TO:
 ATTN:
 SUBJECT: HF Hitch Improvements for 3320 and 3720 drills

FIX ON FAILURE (Failure Code 21.19)

Anti-turn
Base end of
cylinder shown

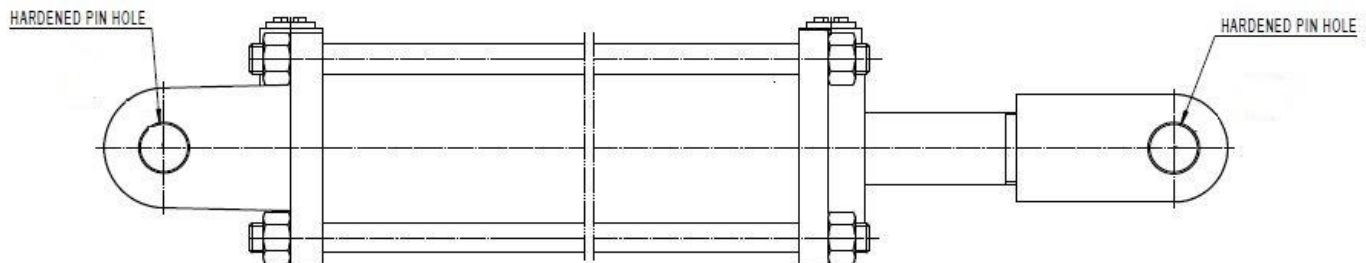
#2 - HF Cylinder – Change to Gr 8 bolts and anti-turns

The bolts that attach the HF cylinder to the rest of the hitch components have been upgraded to a GR8 bolt. The GR8 bolt has a longer shank that keeps threads out of the load bearing area and its “harder” material resists wear much better than a gr5 bolt. In addition to the gr8 bolt an anti-turn has been added to each bolt to prevent it from turning during normal hitch movement thereby preventing wear to the cylinder lugs.

CORRECTIVE ACTION:

- Replace Gr5 bolts with Gr8 bolts and add the associated anti-turn device to each.

#4 - HF Steering box / lug replacement – (units after sn: 43320PH-01 have new QT100 lug)

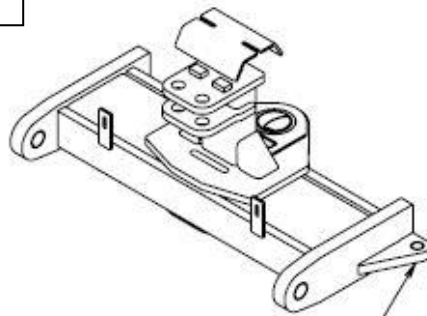
An area of concern is the lug to which the base end of each HF cylinder attaches. This lug is part of what we call the steering box. It is common to see significant wear or damage to the hole in this lug, therefore in order to achieve a lasting repair this lug must be replaced or the entire steering box replaced.

CORRECTIVE ACTION:

- Remove existing worn lugs and weld on the newer version made from QT 100 material which is much harder and resists wear and damage better than the original.

AFFECTED CYLINDER LUG

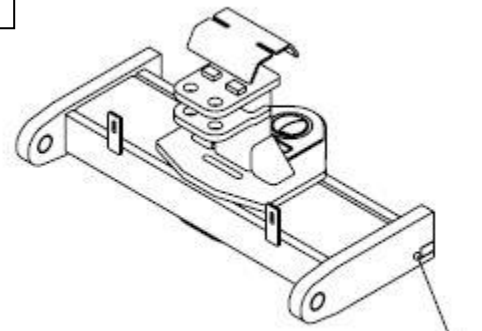
ANALYZE, IDENTIFY LUG

STEP 1

PREPARE SURFACE

STEP 2

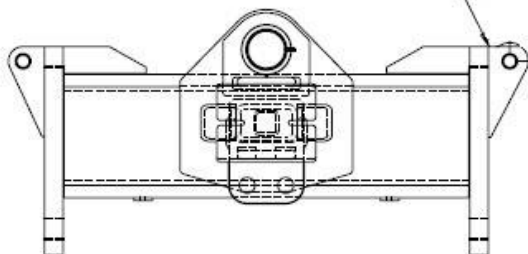
CUT OFF LUG, MAKE FLUSH WITH PLATE SURFACE
CLEAN UP, PREP TO WELD

STEP 3

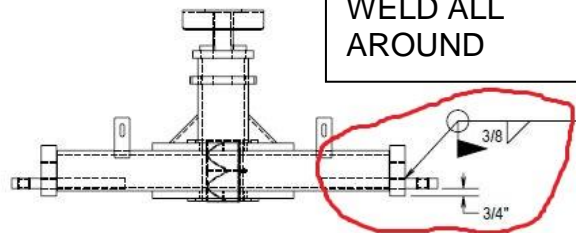
THIS EDGE FLUSH
REFERENCE POINT

HIGH FLOTATION STEERING AS VIEWED FROM BELOW
 (HITCH IS FULLY ARTICULATED)

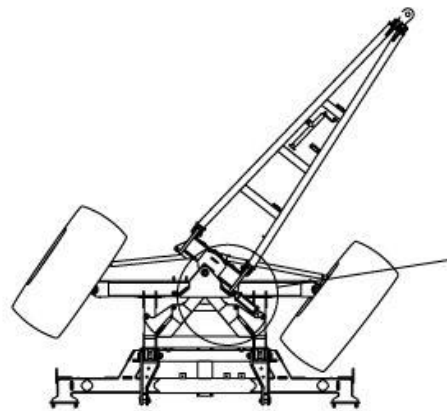
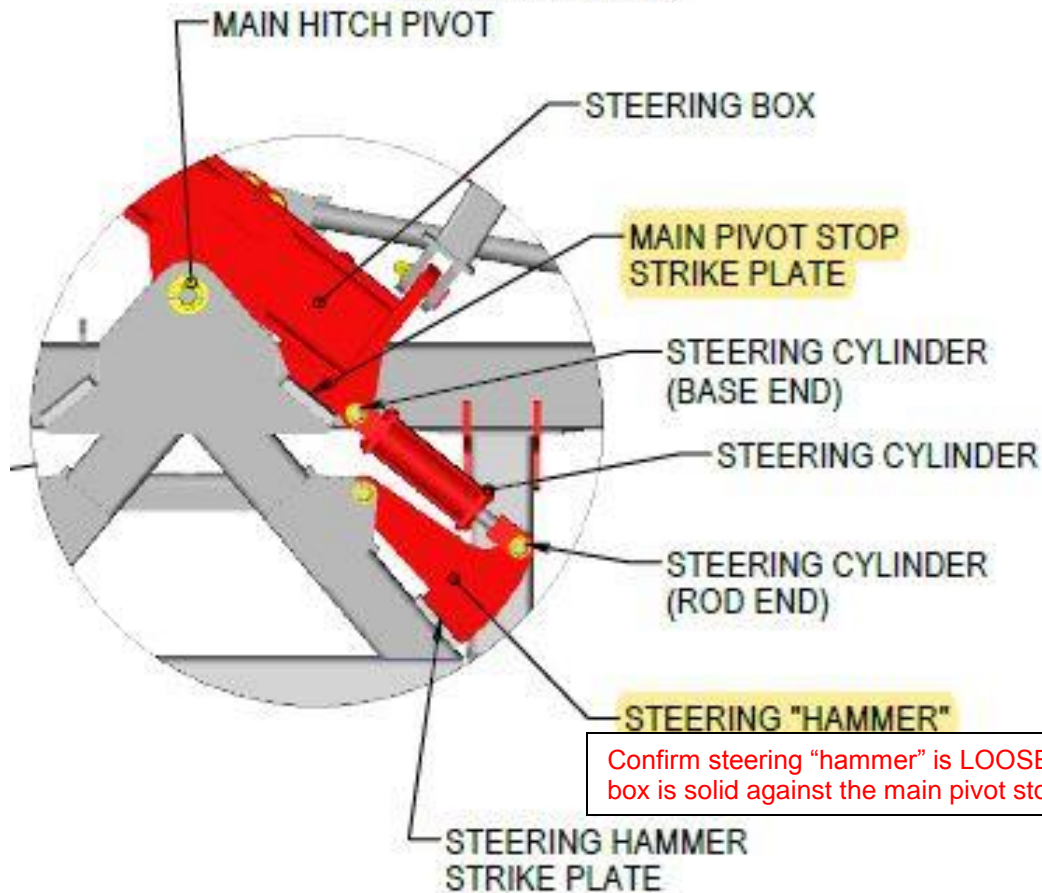
#5 - HF Cylinder – confirm HF cylinder is not crushed when hitch is fully articulated
CORRECTIVE ACTION:

- Due to the relatively high number of pivot points and the ability to have tolerances stack up it needs to be confirmed that the HF cylinder is not being crushed when the hitch is being fully articulated.
 - When the steering box is solid up against the **main pivot stop strike plate** the **steering hammer** needs to be “loose”
 - If the steering hammer is not loose then the cylinder clevis needs to be adjusted shorter to provide adequate clearance for the steering hammer
 - Adjust and repeat as required.

Confirm steering “hammer” is LOOSE when the steering box is solid against the main pivot stop strike plate

Differences for 3320-86’ units

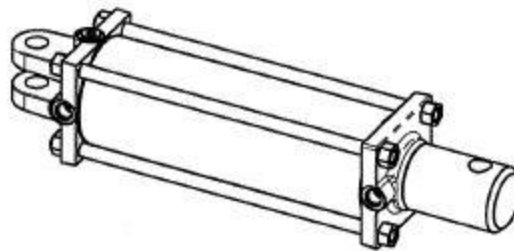
- 3320-86’ units built prior to sn: 42773PH-01 use many of the same components as what is listed in the previous pages and the areas of concern (#1 thru # 6) can be resolved as indicated on the previous pages.
- 3320-86’ units between sn: 42779PH-01 and sn: 43003PH-01 were built with a few differences
 - #1 – HF Cylinder – Orifice Removal - same as instruction indicated on previous pages.
 - #2 – HF Cylinder – Change to Gr 8 bolts and anti-turns - same as instruction indicated on previous pages but only applies to the base end of the cylinder since from new it used a Gr8 bolt and anti-turn device on the rod end.
 - #3 - HF Cylinder – Change to cylinder with hardened clevises - A different HF cylinder is used which has a “boss” style on the rod end.

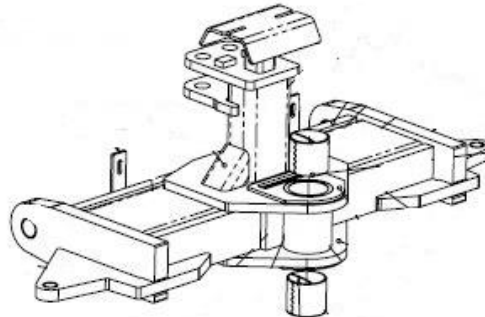
- #4 – HF Steering box / lug replacement - the concern with lug wear has not been seen on 86’ units, so a weld-on lug has not been created – IF you require a weld-on lug please contact your service representative.
 - The complete steering box is available as an assembly
